MEMORANDUM

Department of Building and Planning

RE: Kendall Toyota – Internal Illumination of Entry Wall – Determination of
Architectural Harmony

Illumination Study

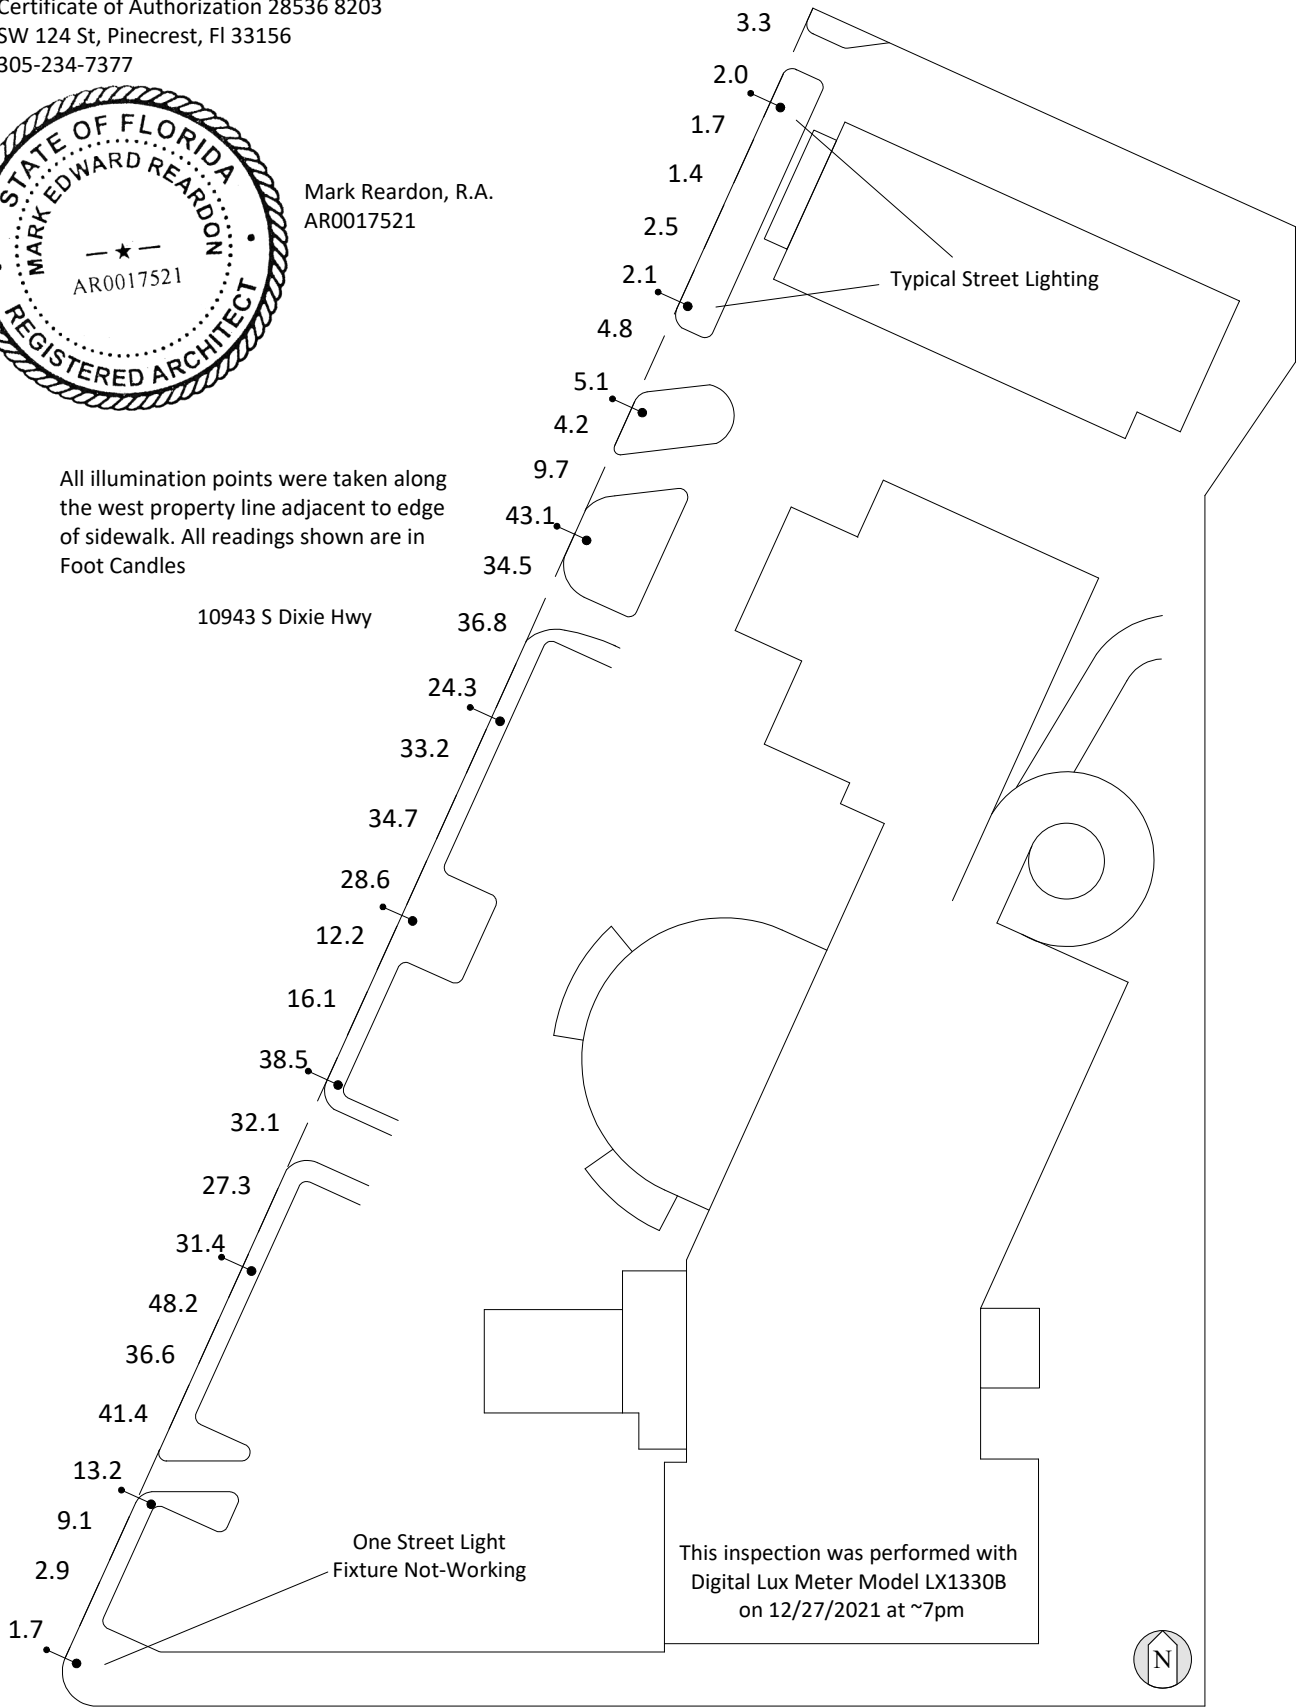
An Illumination Study, completed by Allied on December 27, 2021 (attached) confirmed lighting levels at the Kendall Toyota property line adjacent to Pinecrest Parkway to be as high as 48.2 foot-candles, or 96.4 times greater than otherwise permitted by code today. Additionally, a field inspection completed by the Building and Planning Department confirmed that several of the existing lights on the subject property are not shielded and are causing glare. Photographs showing lighting conditions on the subject property are provided on pages 7 and 8 of this report.

All illumination points were taken along the west property line adjacent to edge of sidewalk. All readings shown are in Foot Candles

EXHIBIT F

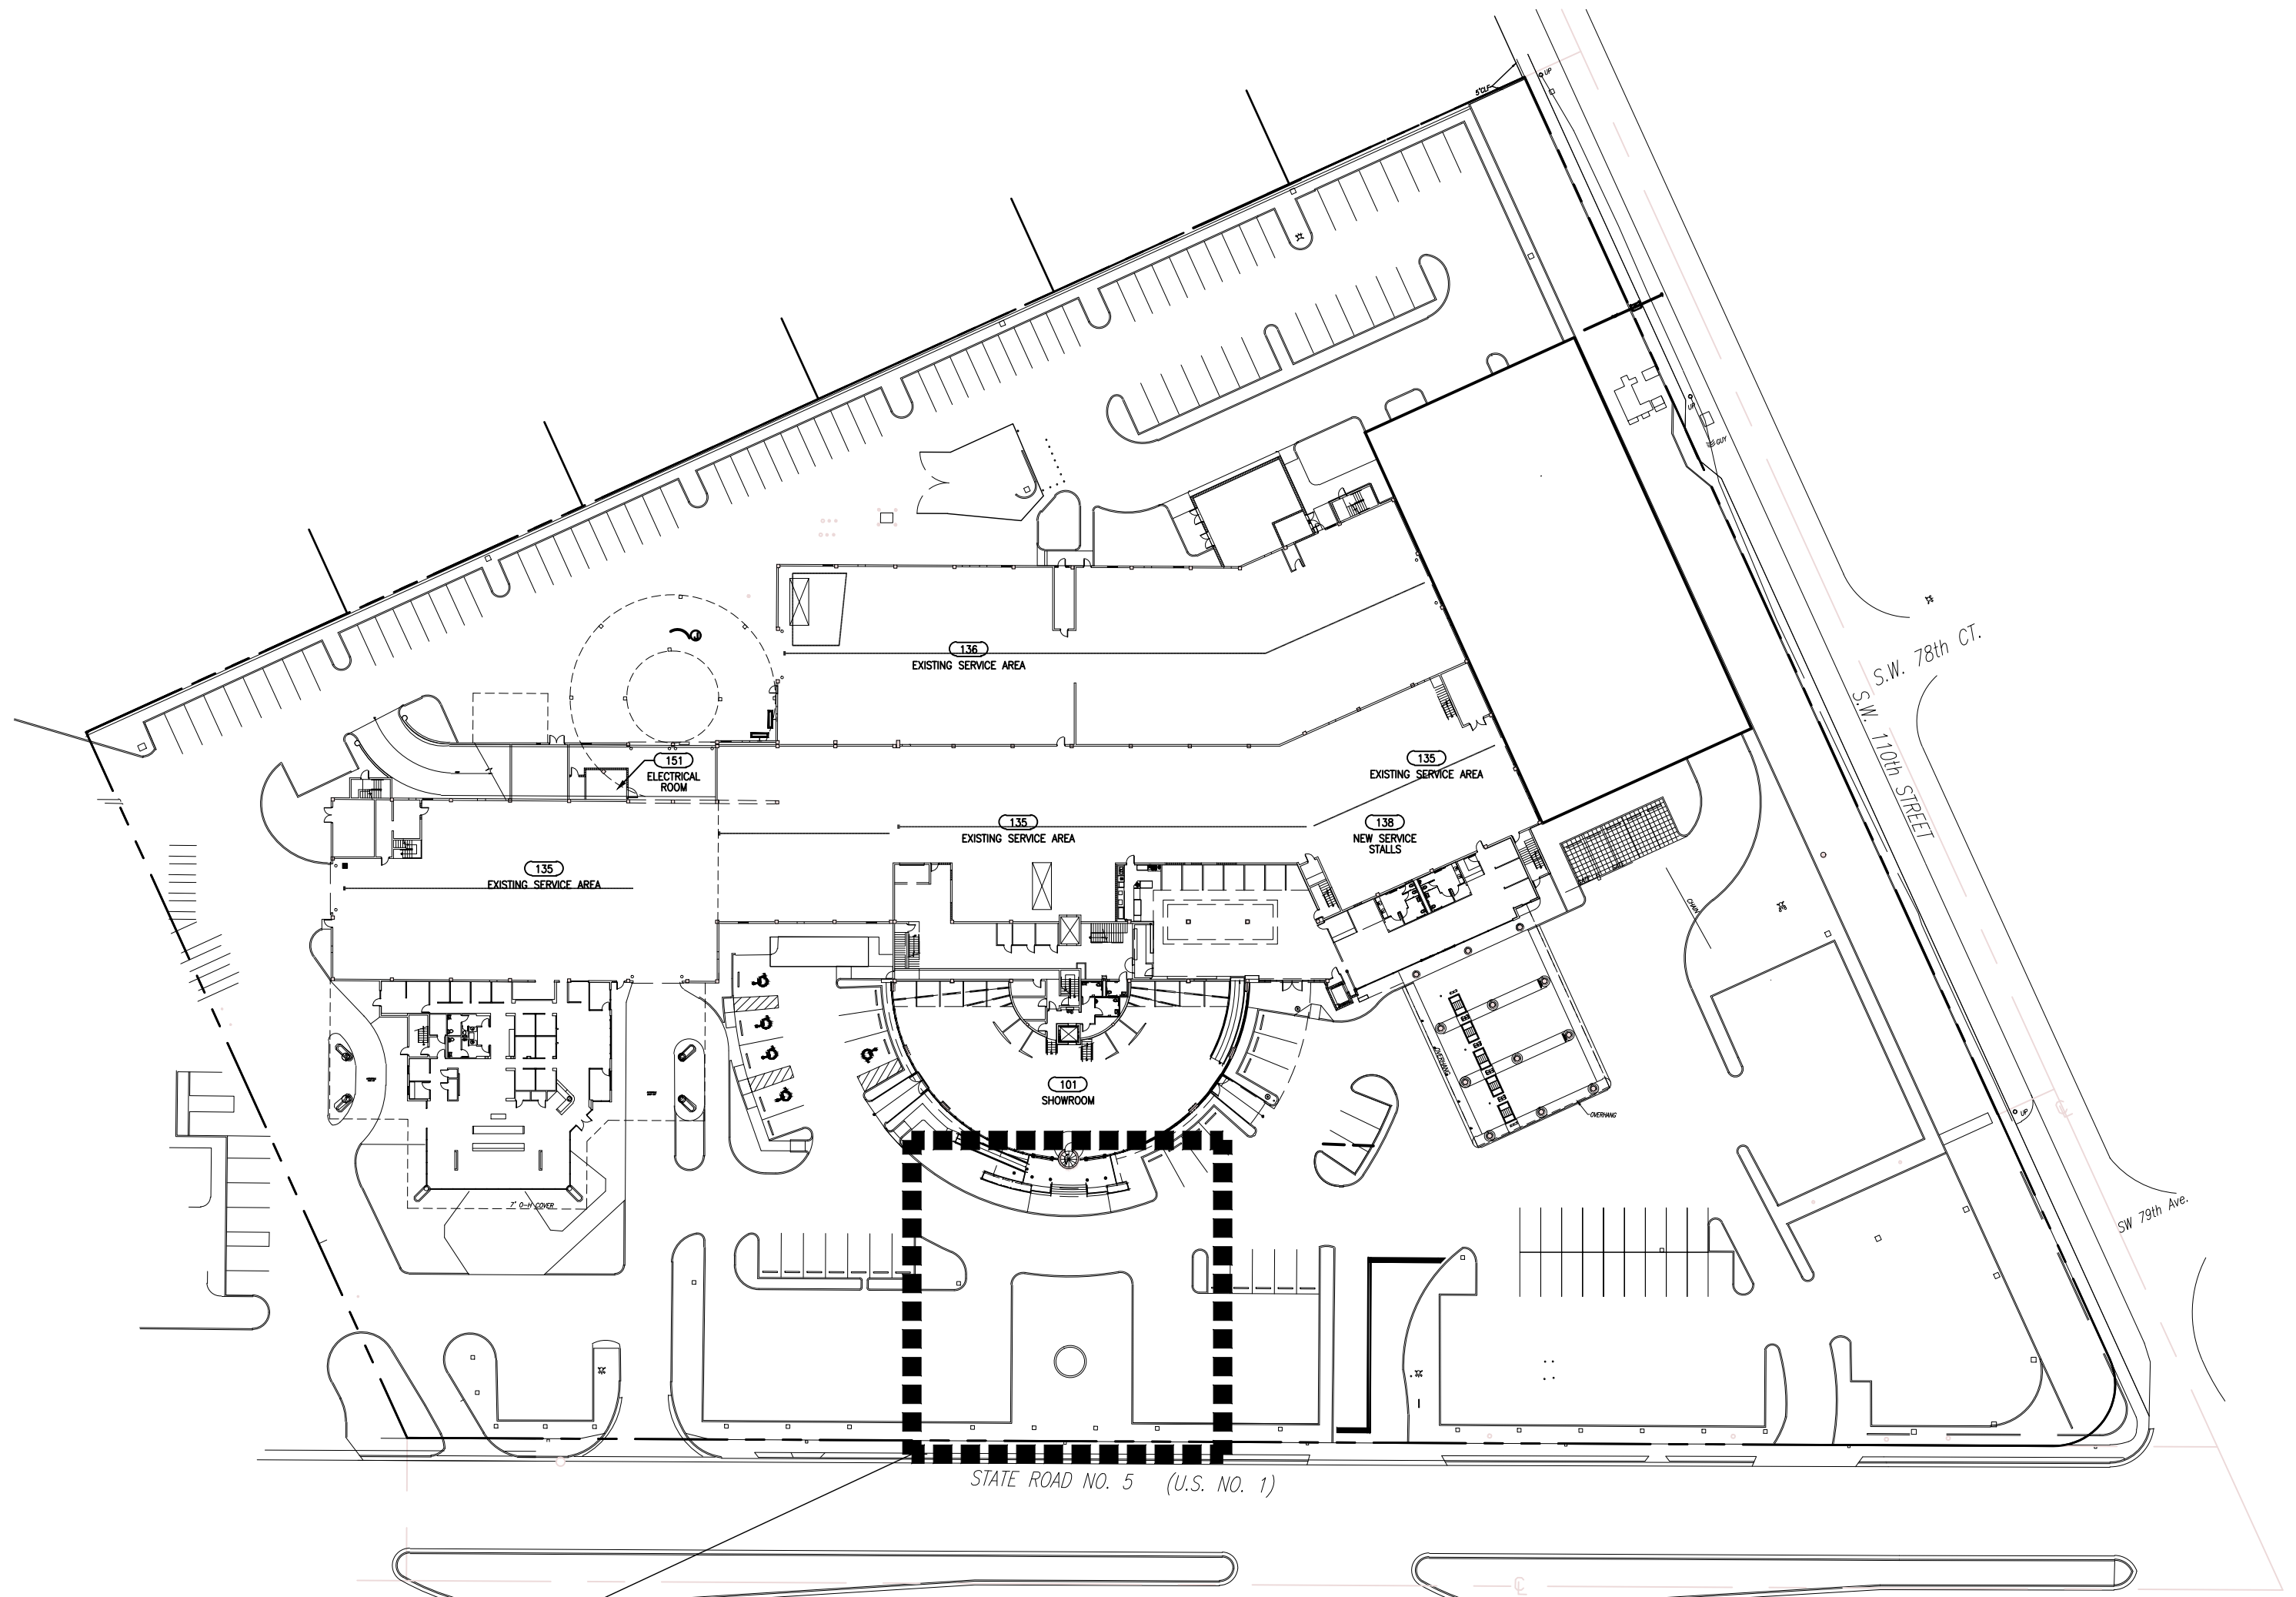
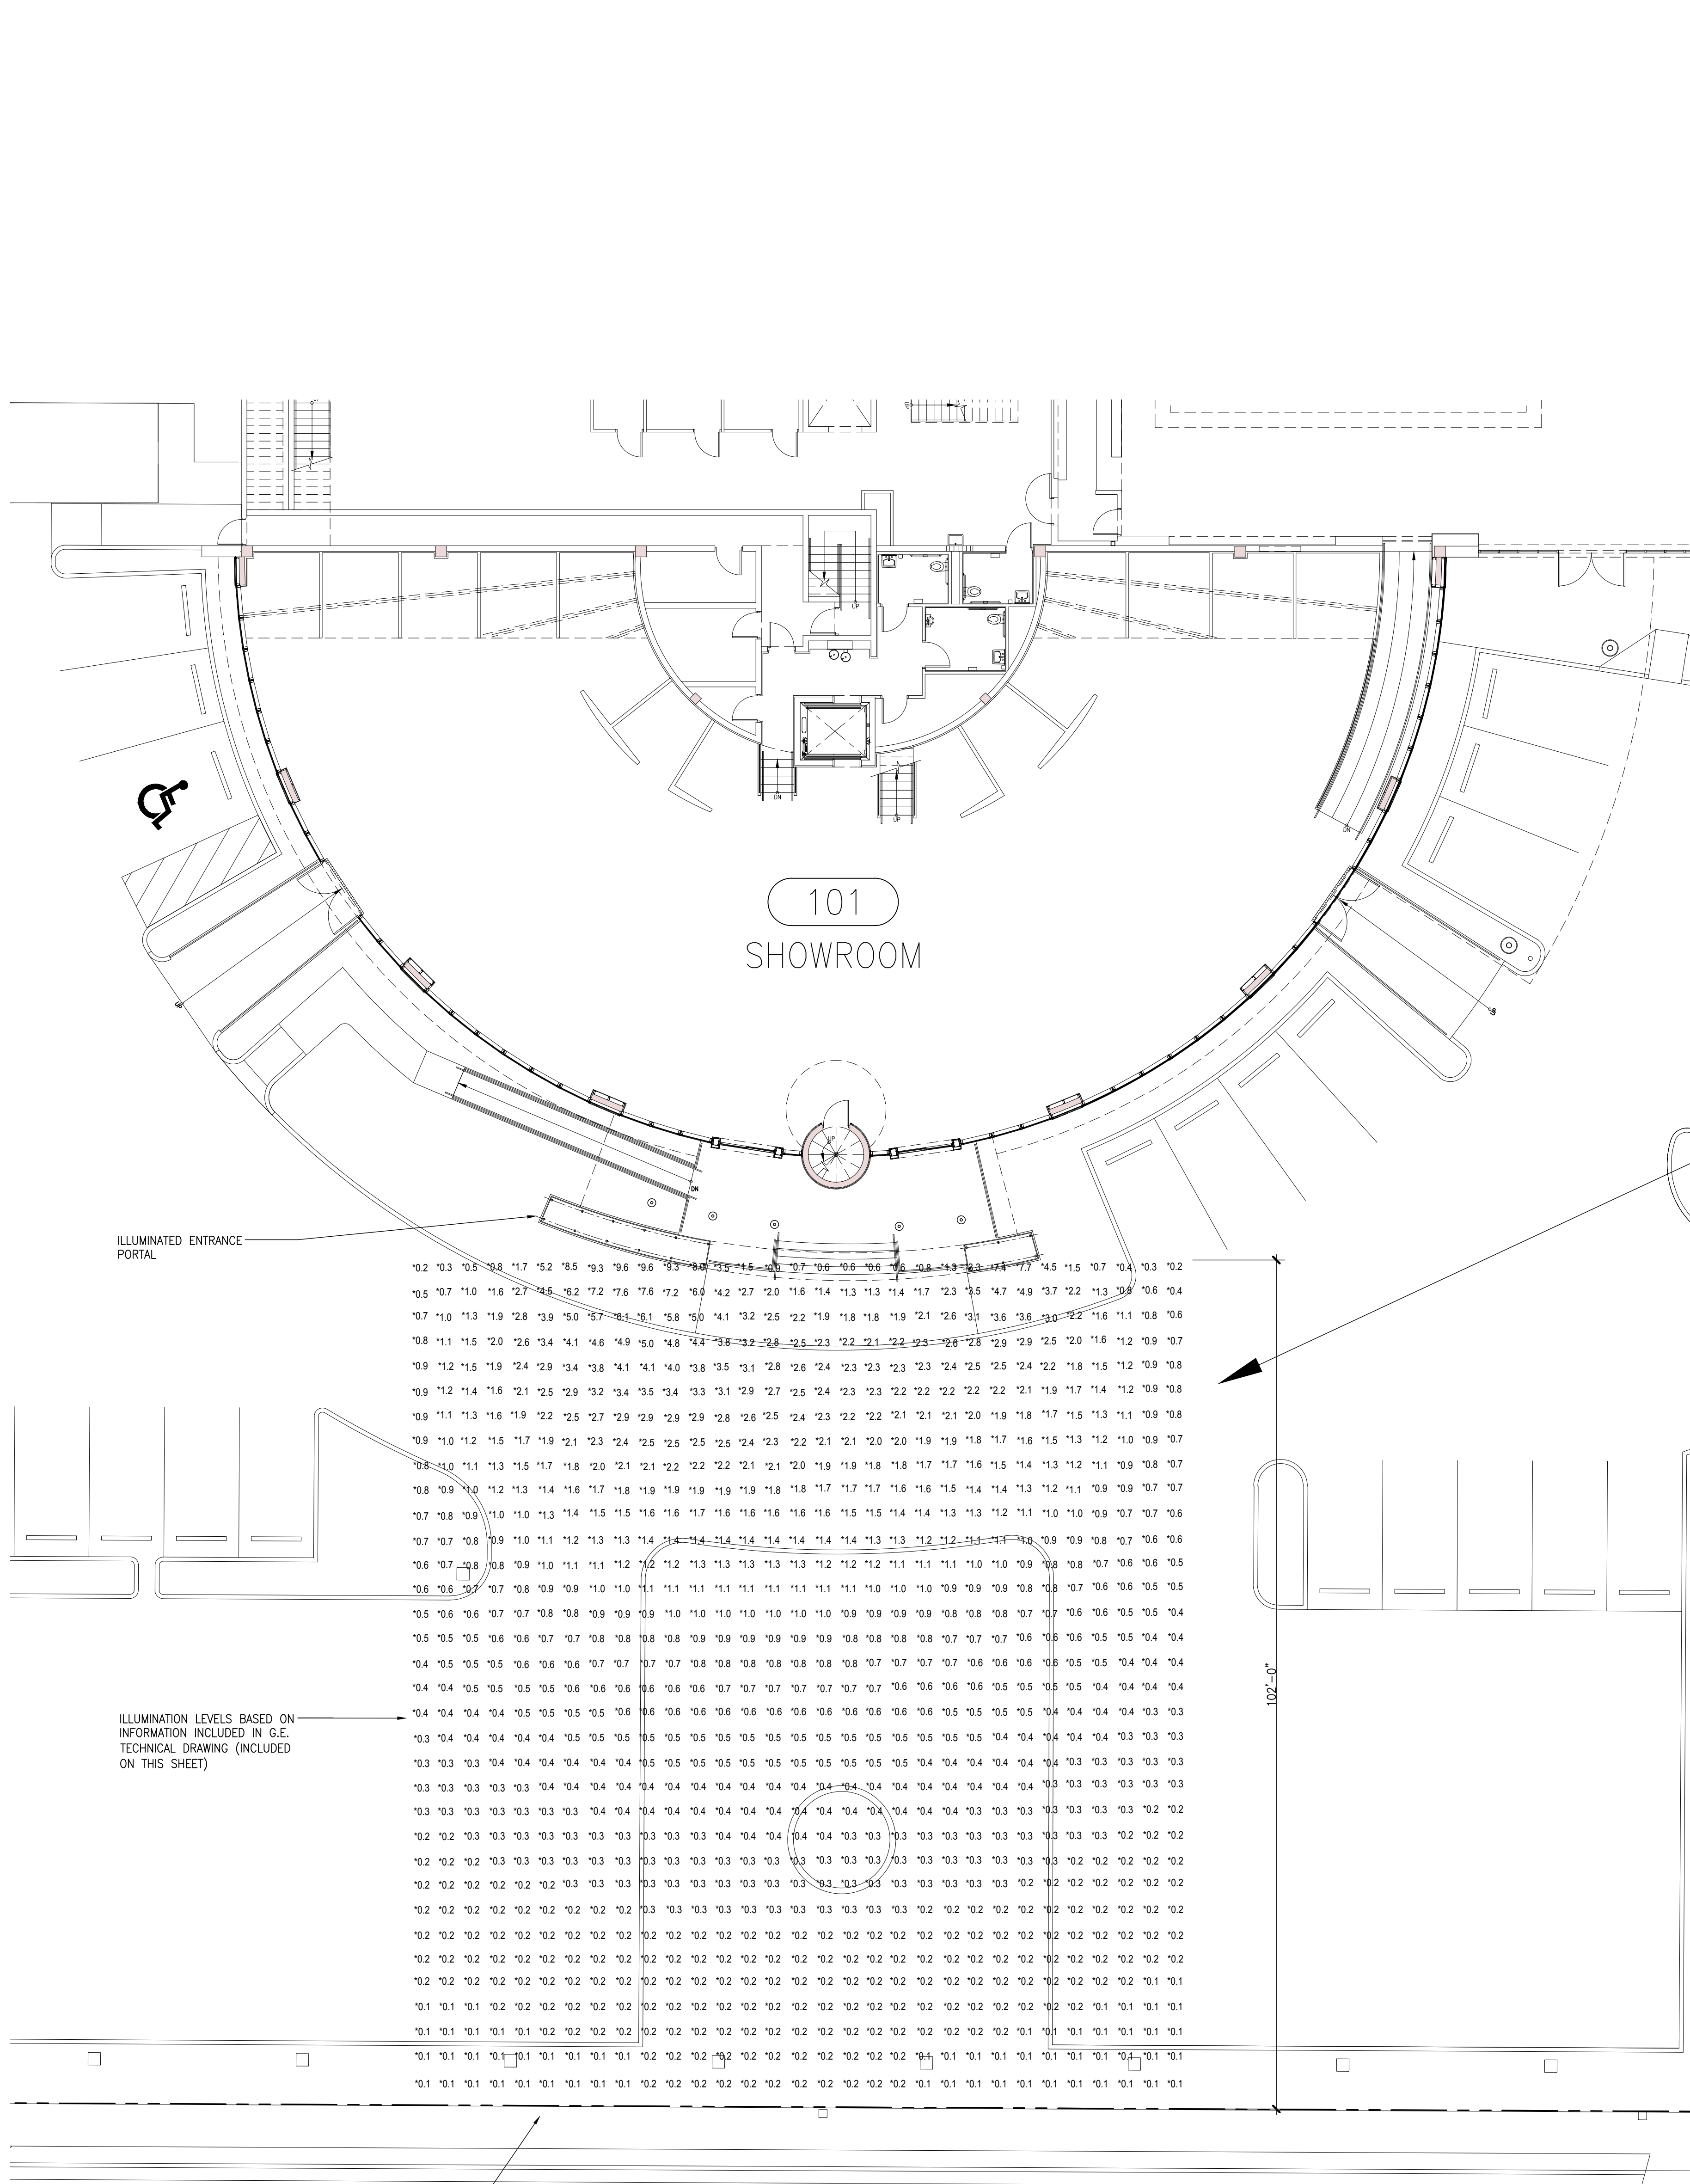
Division 7.14 of the Code regulates the illuminated signs. While the entrance portal is not an illuminated sign, the existing Toyota sign will be illuminated by interior lighting. Division 7.14 expressly provides that the signs may be illuminated by interior lighting. The Entrance Portal does not provide any "indirect lighting from any external source", all lighting is interior to the portal. No indirect lighting from any external source will shine directly on adjacent property, signage, motorist or pedestrians, or illuminate an area greater than the area occupied by the permitted signage. See Exhibit F, Photometric Plan.

the accompanying photometric plan, the Applicant's proposed illuminated interior lighting does not overspill at more than 0.5 foot candle vertically or horizontally onto adjoining properties or street rights-of-way and does not cause any reflected illumination onto adjacent properties, structures, or rights-of-way in compliance with Division 5.25 of the Code.
